From: Haae, Glenn
Sent: Monday, February 10, 2020 10:27 AM
To: Sage Kiyonaga
Cc: Ichinotsubo, Lene K; Moore, Caleb; Becerra, Virginia
Subject: Molokai ISWMF Renewal w/ Modification Application (Phase V, Phase VI) Comments/Questions

Tetra Tech General Comments on Seismic Stability Analysis, Molokai Integrated Solid Waste Facility, May 2019, A-Mehr (Appendix C of the October 2019 Design Report)

SUBJECT: RESPONSE TO COMMENTS, PHASE 5 & 6 SWFP APPLICATION
MOLOKAI INTEGRATED SOLID WASTE MANAGEMENT FACILITY
SOLID WASTE MANAGEMENT PERMIT LF-0070-09

Figure 1A

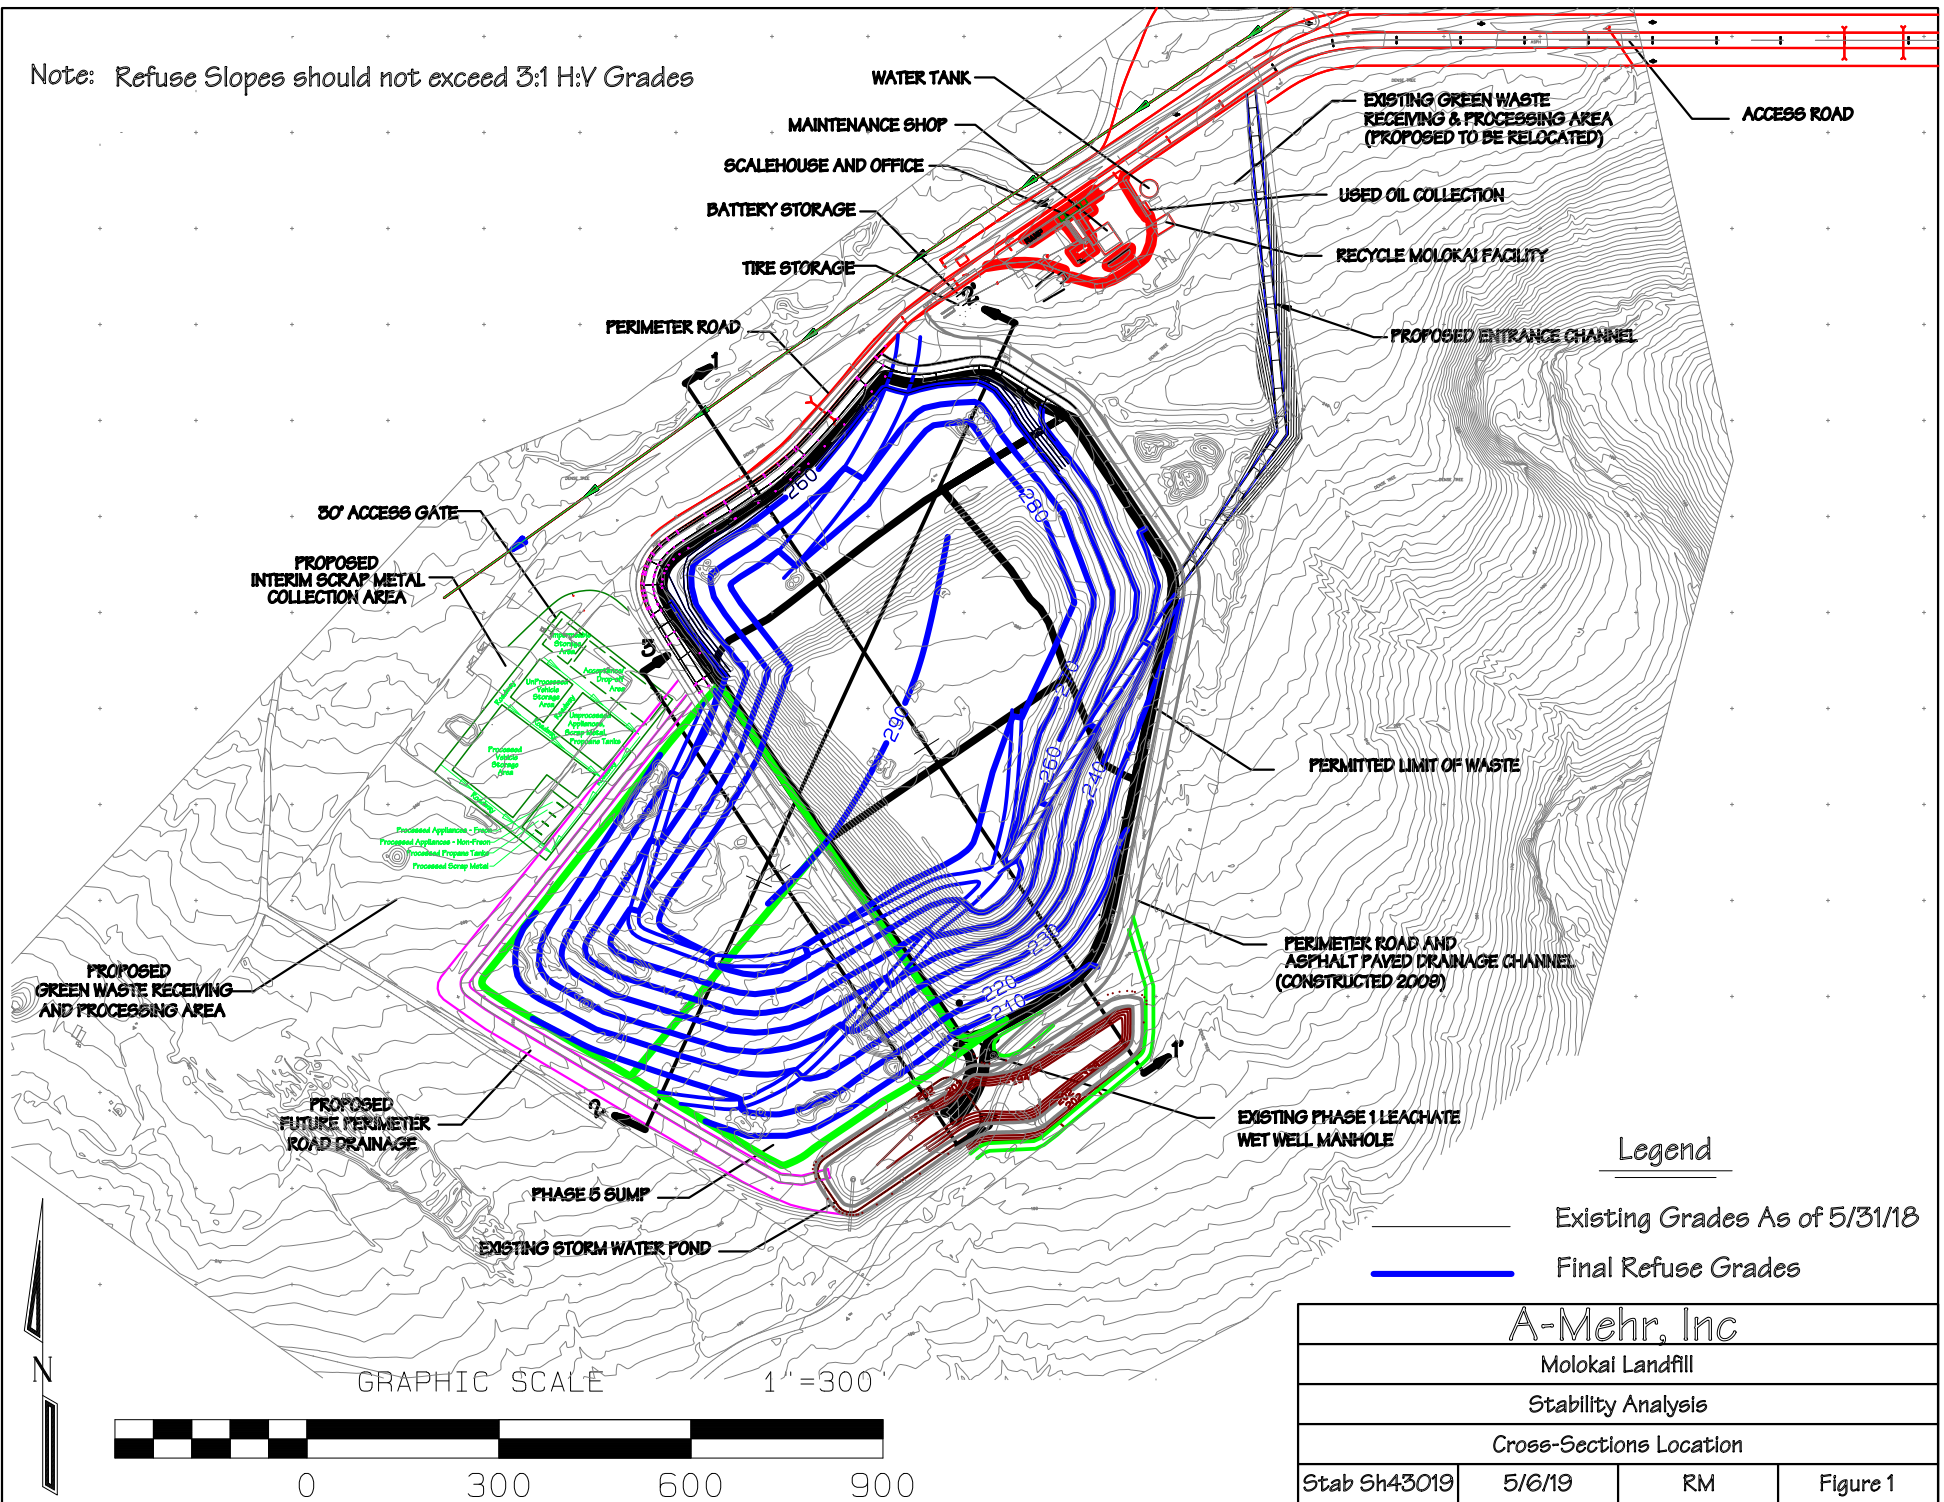
- Please clarify how the estimated peak ground acceleration of 0.31g was obtained for the design earthquake (i.e., an earthquake with a 2,475-year return period or 2% probability of exceedance in 50 years). The report referred to Figure 1 for the estimated design PGA. However, it appears Figure 1 shows the grading plan and cross-section locations for the facility. Note, the reviewer estimated the design PGA using the USGS Unified Hazard Tool and ASCE 7 Hazard Tool, and the adopted PGA of 0.31g is acceptable.

An update to the Appendix B, Operations Plan is attached (Attachment D) which incorporates and references Figure 1A and which was used to estimate the PGA for the project location.

A-Mehr, Inc			
Molokai Landfill			
Stability Study			
Cross-Section 1-1' & 2-2'			
Stab Sh43019	5/6/19	RM	Figure 5

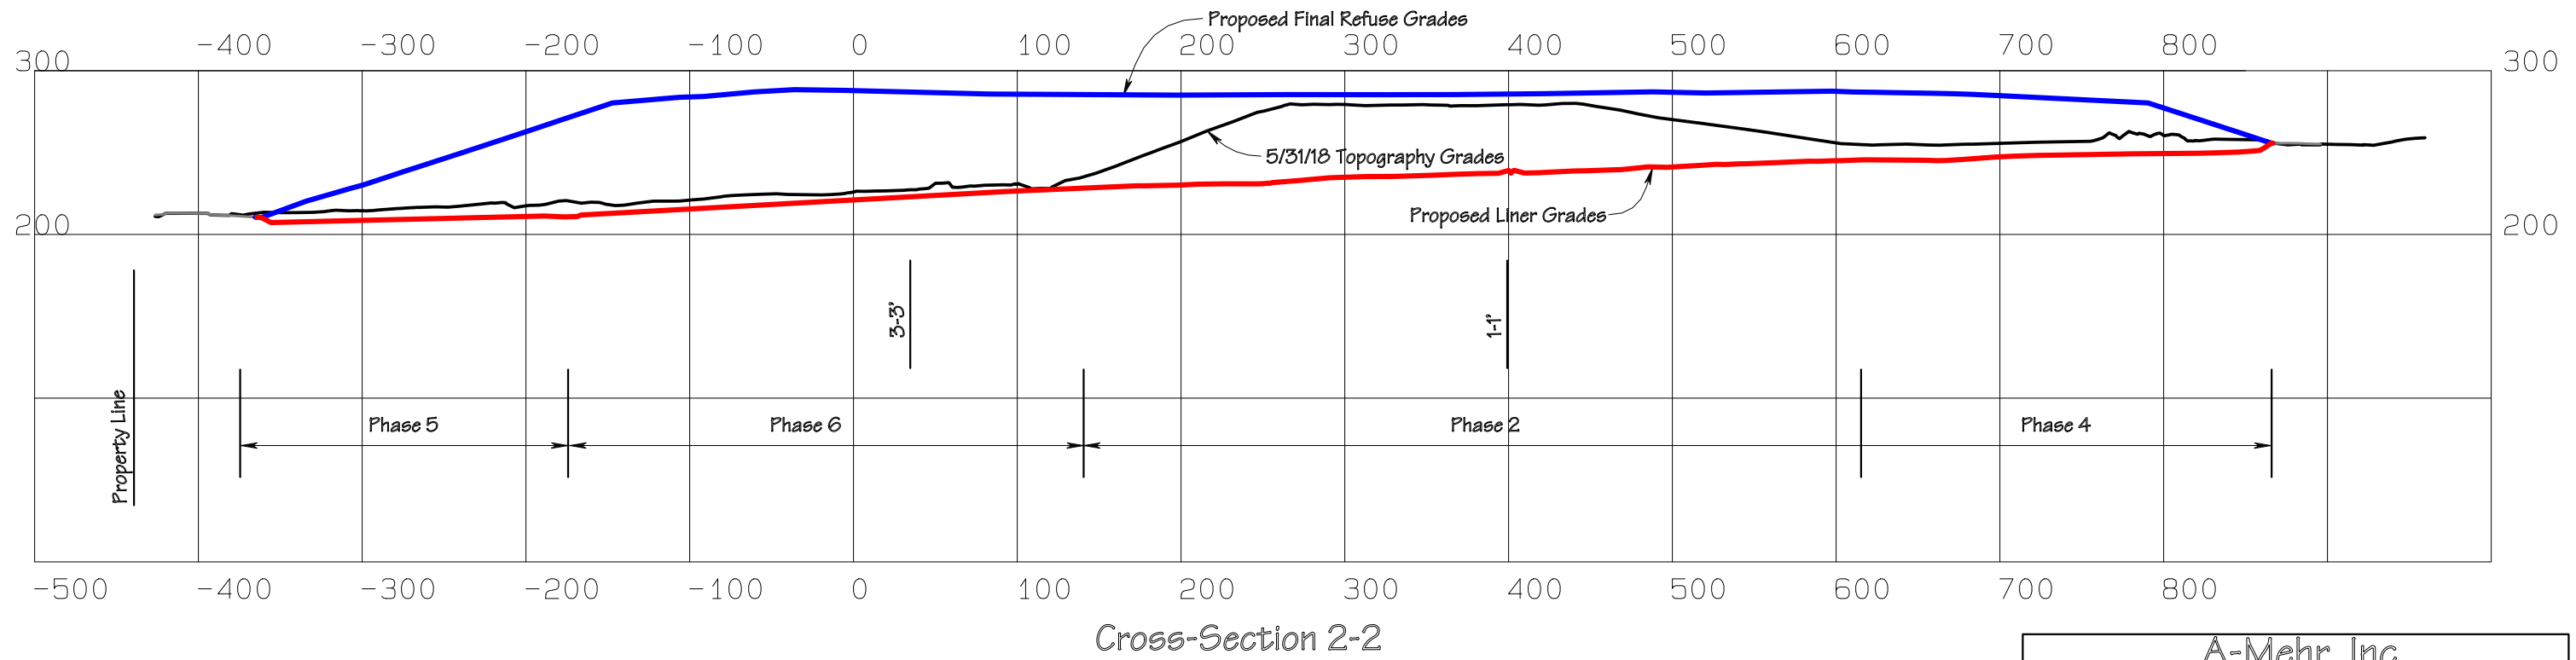
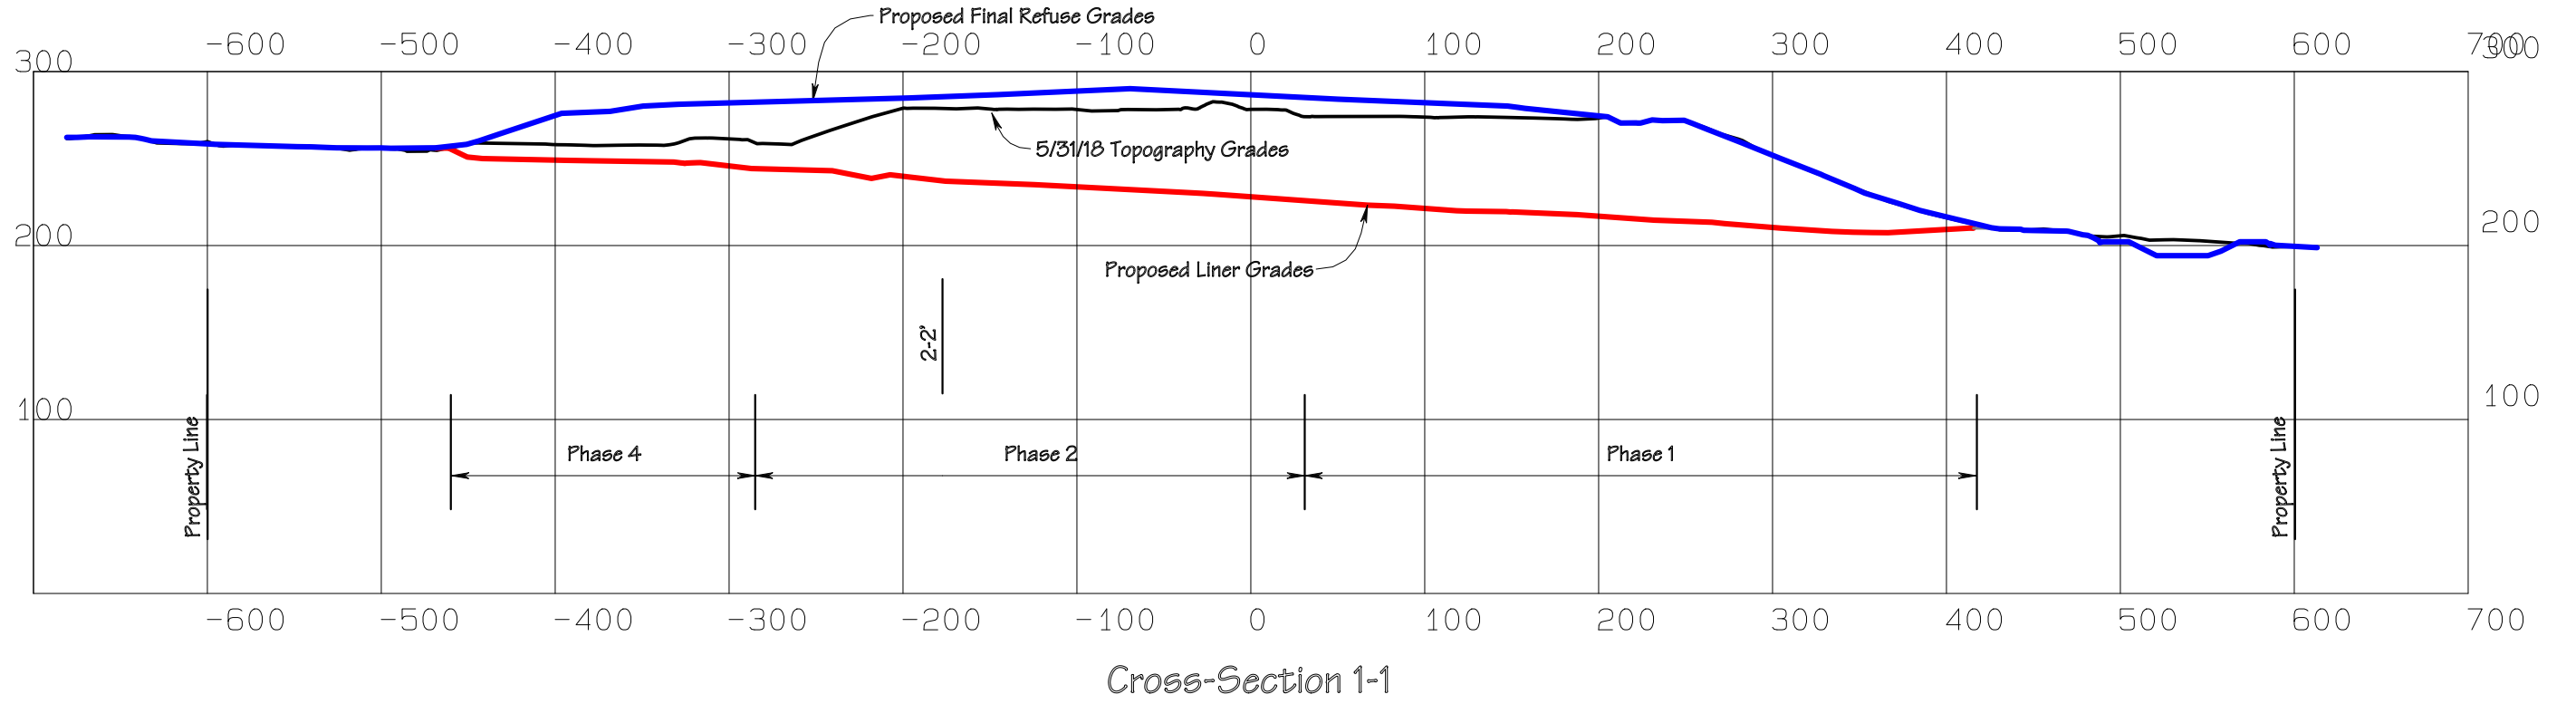
- Please clarify the groundwater conditions in the report text or in the computer output sheets in Appendix B. In the output sheets, the piezometer surface is designated as "W1". However, the surface "W1" was not presented in the cross-sections.

Groundwater below the landfill is estimated to be at least 175 feet below the liner grades and in the hard bedrock. The output file default print out includes this generic information

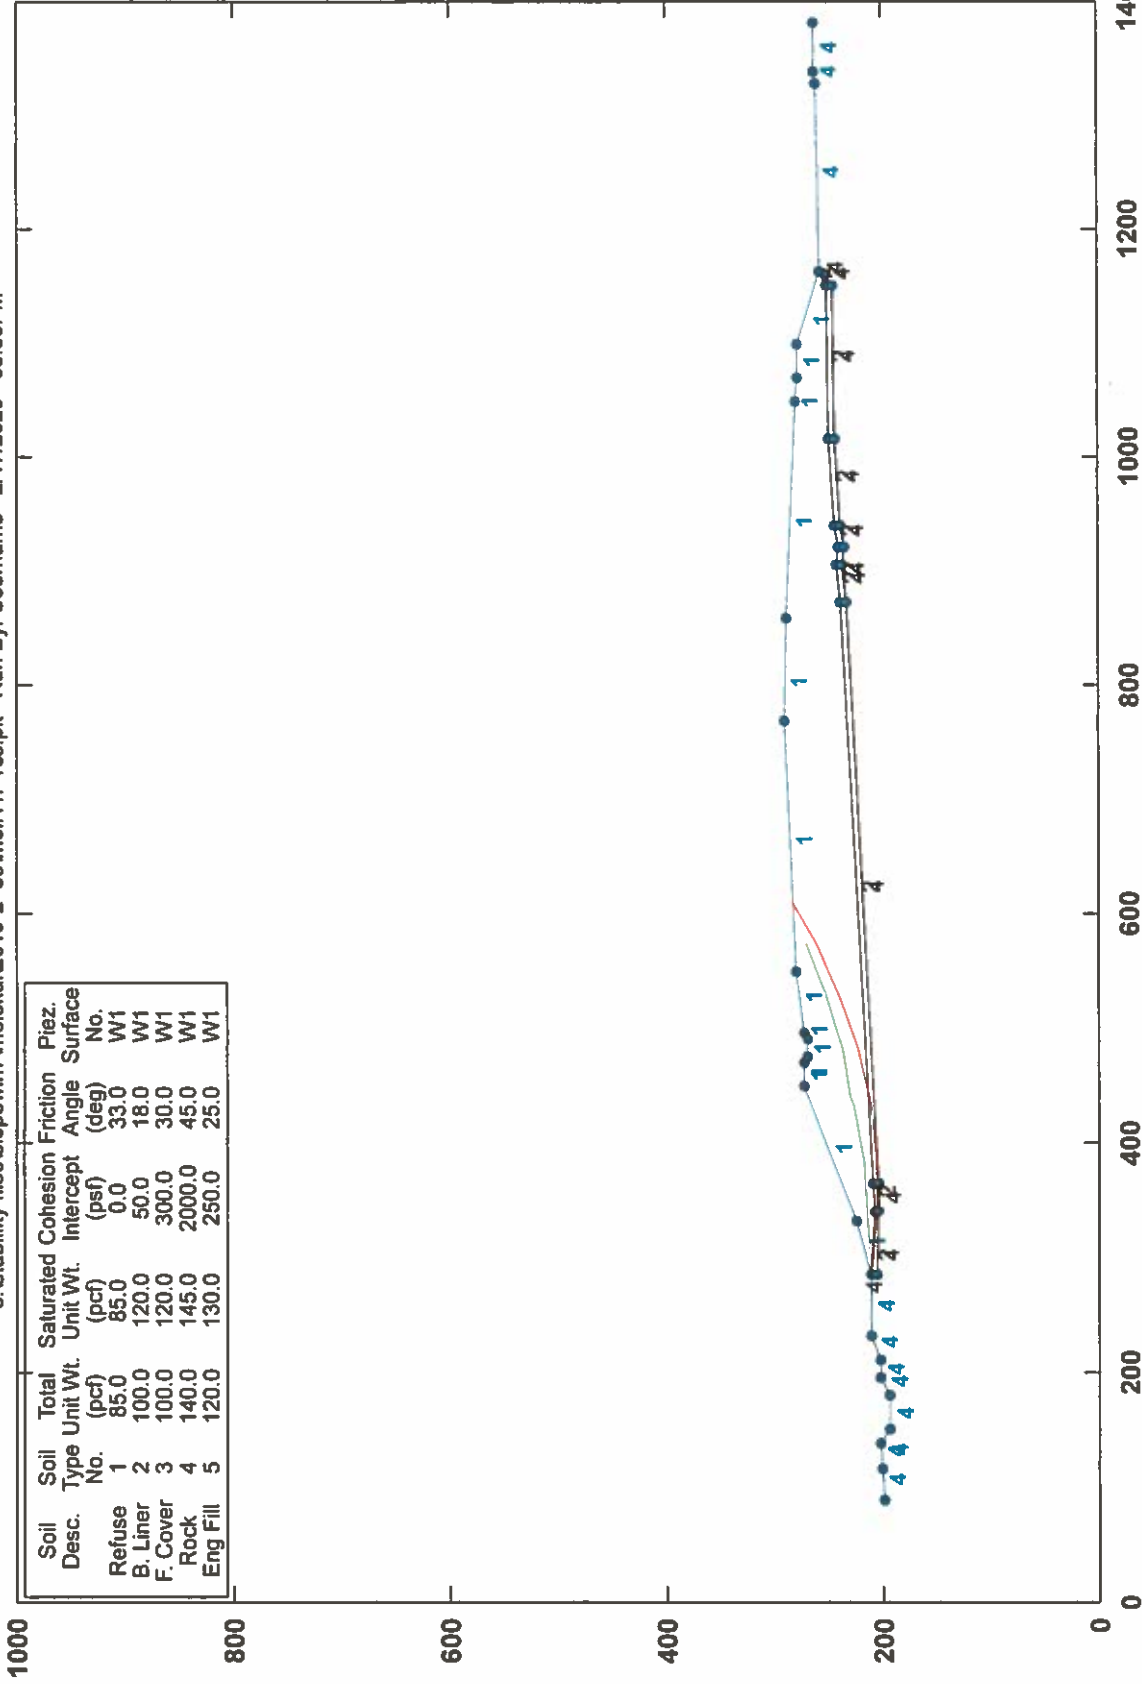
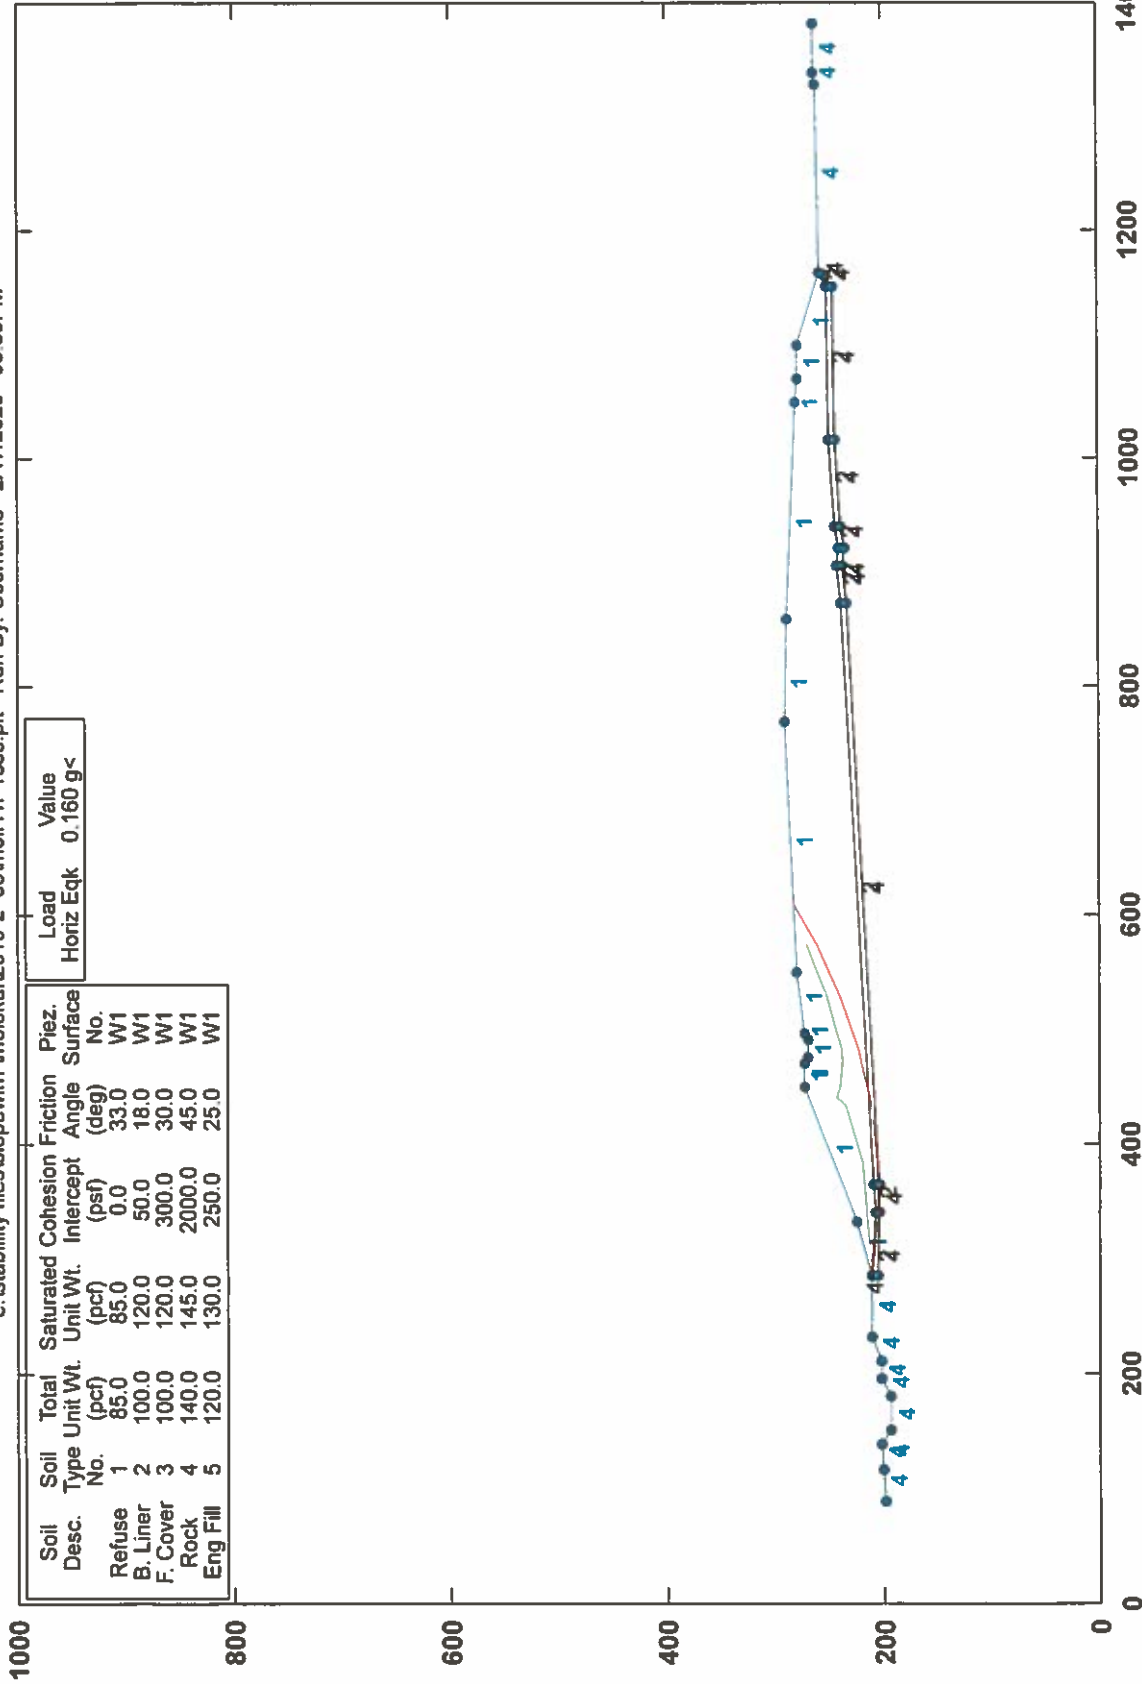
- Please verify/confirm that the Spencer's Method was used to calculate the critical static and pseudostatic Factor of Safety for cross-section 1-1. The "Modified Bishop Method" was labelled in the computer output sheets for the static FS = 2.39 and pseudostatic FS = 1.35.

The lowest safety factor using Spencer's Method resulted in static FS= 2.38 and pseudostatic FS= 1.32 for cross-section 1-1. The summary of analysis results presented in the attached Appendix B, Operations Plan (Attachment D) is updated to include the method of slope stability analyses and these results.
